TO: License Fee Management Branch
FROM: Patricia C. Vacca
SUBJECT: VOIDED APPLICATION

Control Number: 021443
Applicant: Siemens Analytical X-Ray Instruments
Date Voided: November 23, 1993
Reason for Void: Licensee's ltr dtd 11/16/93
specifically requests NRC to abandon this application.

Reference Control Number 021443

This concerns the information and product sample delivered by Ms. Engelhardt on August 10, 1993, in response to our letter dated July 14, 1993, informing you that additional information was needed in order to continue our review of your request for an exempt distribution license.

Figure 15. Attaching the Fe⁵⁵ Source

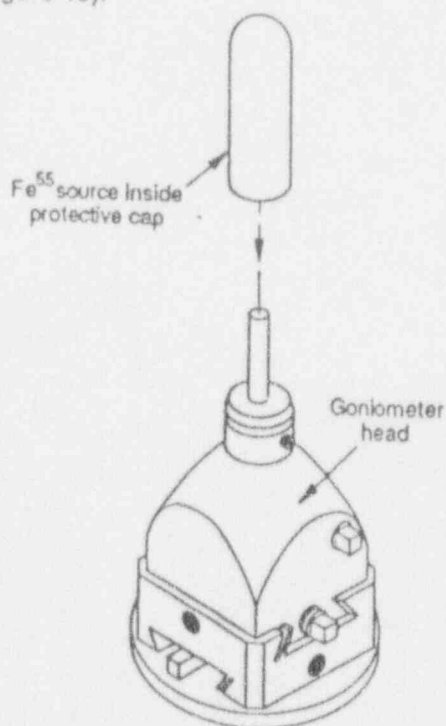
1. The brochure you provided entitled, "5.2 Fe-55 Source Calibration," states, "Attach the Fe-55 X-ray source onto the sample holder (Figure 15)." Figure 15 appears to indicate that the Fe-55 source is attached to the source holder and covered with a protective cap to later be installed onto the calibration device. However, from the product you provided for review, it would seem that the source holder containing the Fe-55 source is permanently attached to the calibration device prior to distribution. This incorporation of byproduct material into a device for exempt distribution is clearly prohibited in 10 CFR 32.18(c) which states that "The byproduct material is..., but is not incorporated into any manufactured or assembled commodity, product, or device intended for commercial distribution."

Please note that if our understanding of the device you provided is correct, then the device is prohibited pursuant to 32.18 and cannot be authorized for exempt distribution. If our understanding is incorrect, you must more clearly define the product to be distributed. Is the source attached to the source holder considered the product or is the product the entire calibration device with the source holder and the Fe-55 source? You should also completely describe how the device is attached to the source holder and how the source holder is installed into the device. Your description should indicate whether the customer or the manufacturer of the device installs the source holder onto the device.

Figure 16. Removing the Protective Cap

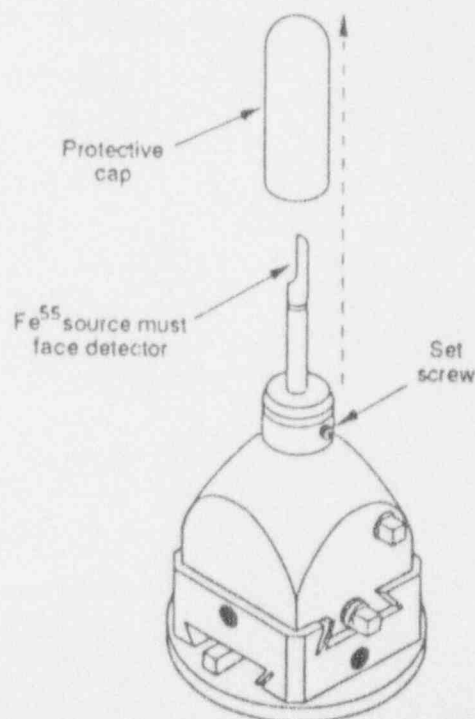
5. The "Warning" statement contained in your product brochure implies a serious safety hazard which is excessive. The products authorized under 10 CFR 32.18 contain very small quantities of byproduct material that have been evaluated and determined safe for distribution to persons without a license. 10 CFR 32.19(d) requires that brochures should provide appropriate additional radiation safety precautions and instructions as to the handling, use, storage, and disposal of radioactive material. The information should discuss basic radiation safety and good laboratory practices, such as time, distance, and shielding; use only as intended by authorized users; storage security; and disposal. Submit an example of the changes you propose to make to the product brochures to be provided to your customers.
